From: Dickson, Laura
Sent: Monday, November 21, 2022 9:51 AM
To: Juarez, Allie M.
Cc: Gorog, Mark
Subject: RE: [External] Methanol Tank Information

CLIENT: Markwest Liberty Midstream & Resources, LLC **JOB NO.** US-107418 **DATE:** 10/17/2017
SUBJECT: Harmon Creek Plant **BY:** SA
P.O. :

Tag No.: TK-1102
Service: Methanol Storage Tank

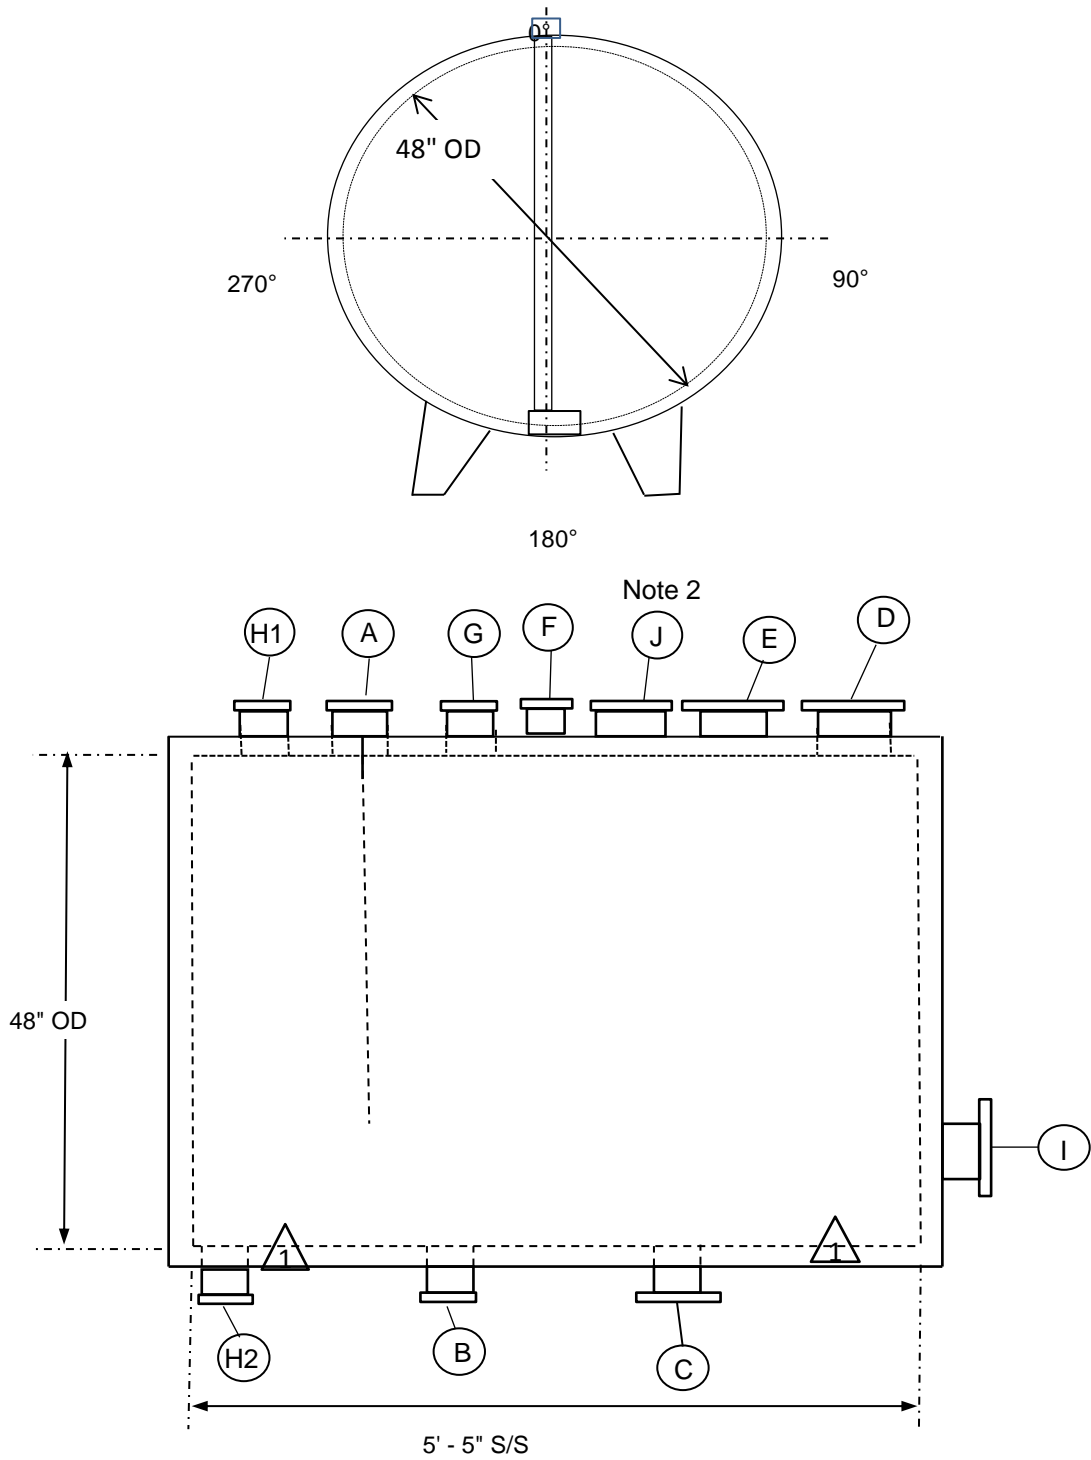
Thanks for providing the spec sheet and information related to the methanol storage tank. During review of the memo, it was mentioned that BAT for a tank that contains VOCs or HAPs should meet the following (below). Will the tank meet this?

Storage tanks with vapor pressure greater than 1.5 psia (10.5 kilopascals) under actual storage conditions - pressure relief valves which are maintained in good operating condition and which are set to release at no less than .7 psig (4.8 kilopascals) of pressure or .3 psig (2.1 kilopascals) of vacuum or the highest possible pressure and vacuum in accordance with state or local fire codes or the National Fire Prevention Association guidelines or other national consensus standards acceptable to the Department.

I received your voicemail. Please find the specifications for the proposed methanol tank attached. The tank will be equipped with vents rated at 150 psi.
